Model: Brz-P1	Date: 23-May-16	No.: RM281002c
----------------------	-----------------	----------------

Subject: Firmware Problems/Original		Reasons for original problem have been corrected or addressed		Prepared by: T. Tachibana	
From: 2nd Tech Service Sect., MFP/Printer Tech Service Dept.					
Classification:	<input type="checkbox"/> Troubleshooting	<input type="checkbox"/> Part information	<input type="checkbox"/> Action required		
	<input type="checkbox"/> Mechanical	<input type="checkbox"/> Electrical	<input type="checkbox"/> Service manual revision		
	<input type="checkbox"/> Paper path	<input type="checkbox"/> Transmit/receive	<input type="checkbox"/> Retrofit information		
	<input type="checkbox"/> Product Safety	<input checked="" type="checkbox"/> Other (Firmware)	<input checked="" type="checkbox"/> Tier 2

Model: Brz-P1		Date: 31-Aug-16	No.: RM281017
Subject: Parts Catalog Correction on Operation Panel		Prepared by: T. Tachibana	
From: 2nd Tech Service Sect., MFP/P Tech Service Dept.			
Classification:	<input type="checkbox"/> Troubleshooting <input type="checkbox"/> Mechanical <input type="checkbox"/> Paper path <input type="checkbox"/> Product Safety	<input checked="" t

7. Fusing Section

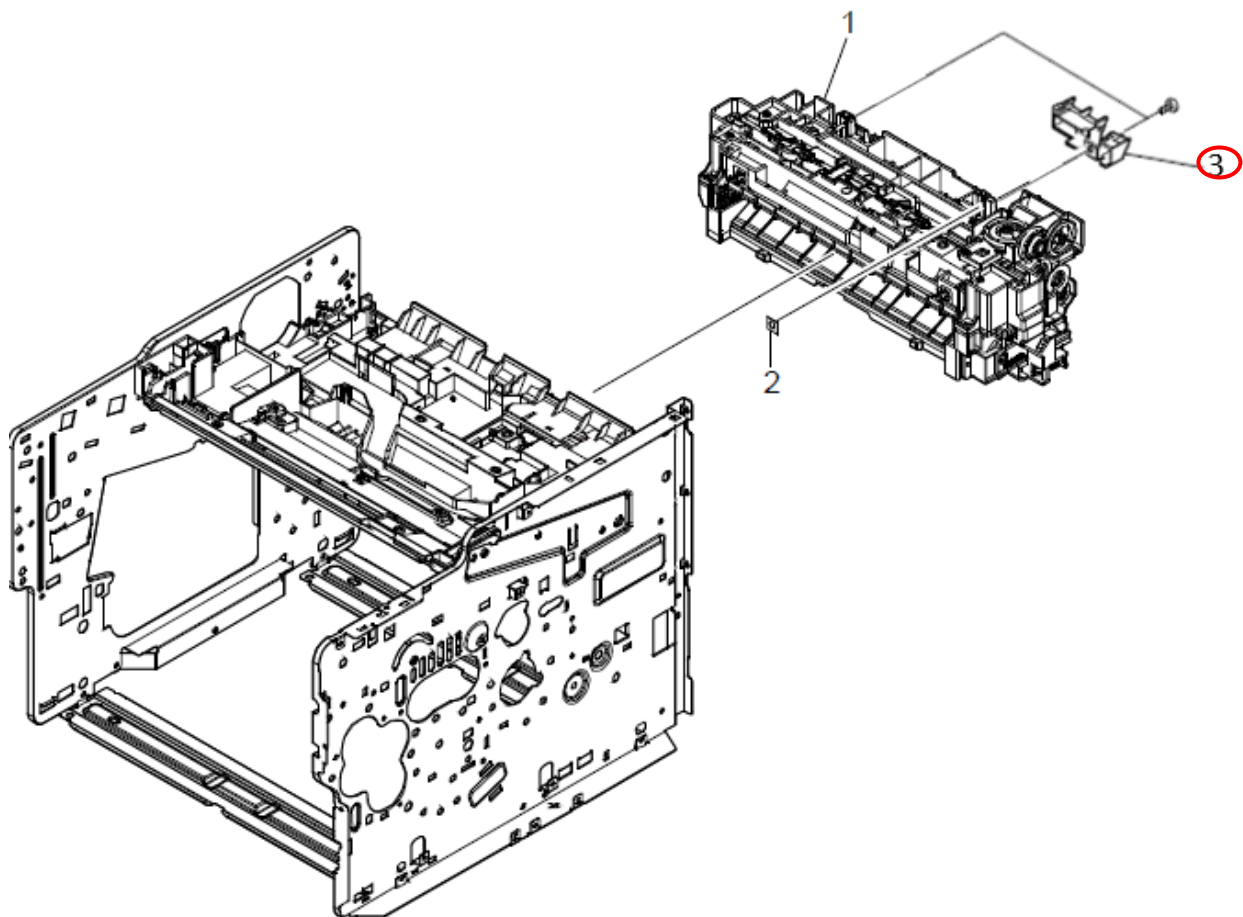
Change: This part is newly added.

Part number	Description	Q'ty	Int	Page	Index	Note
M2811087	COVER SENSOR	1		16	3

1.Covers

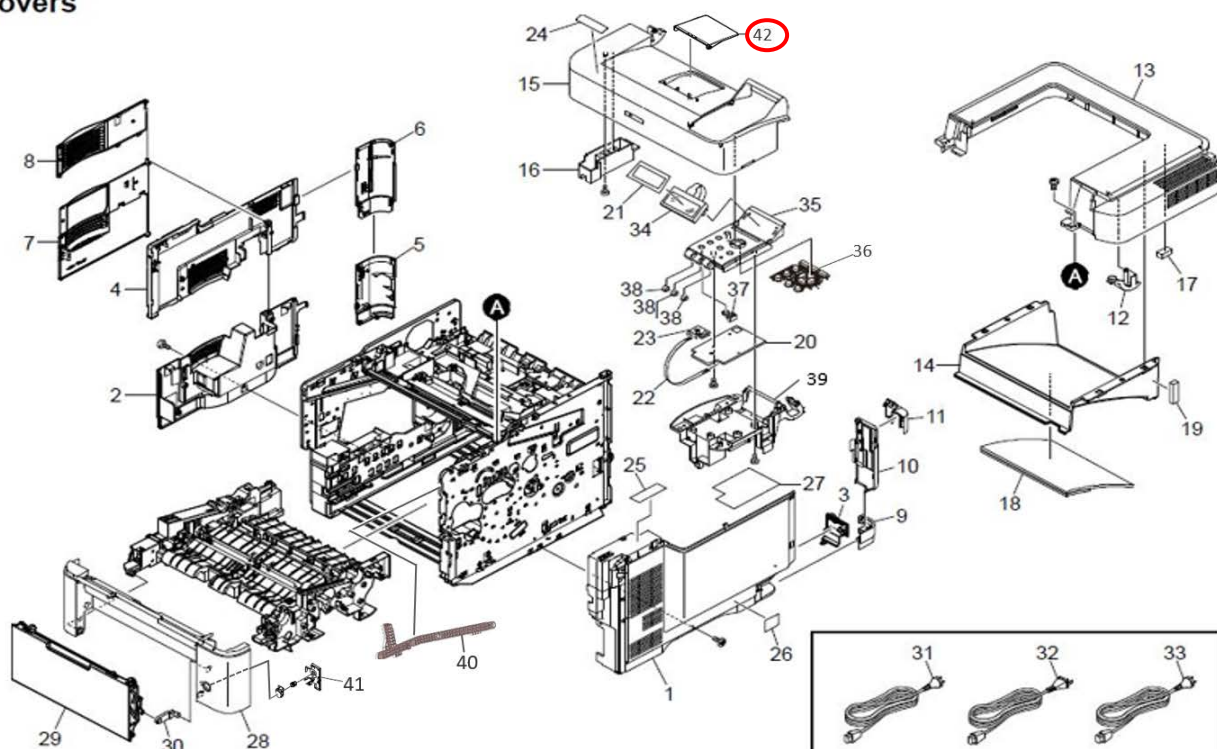
Change: *The bold italic part* is newly added.

Part number	Description	Q'ty	Int	Page	Index	Note
M2811420	LID OPERATION	1		4	35	
M2811424	KEY A	1		4	36	
M2811425	KEY PAUSE	1		4	37	
M2811427	LENS LED	3		4	38	
M2811422	COVER OPERATION	1		4	39	
M2811139	ARM COUPLING	1		4	40	
M2811088	HOLDER KEY SW	1		4	41	
<i>M2811247</i>	<i>PAPER STOPPER</i>	<i>1</i>		<i>4</i>	<i>42</i>
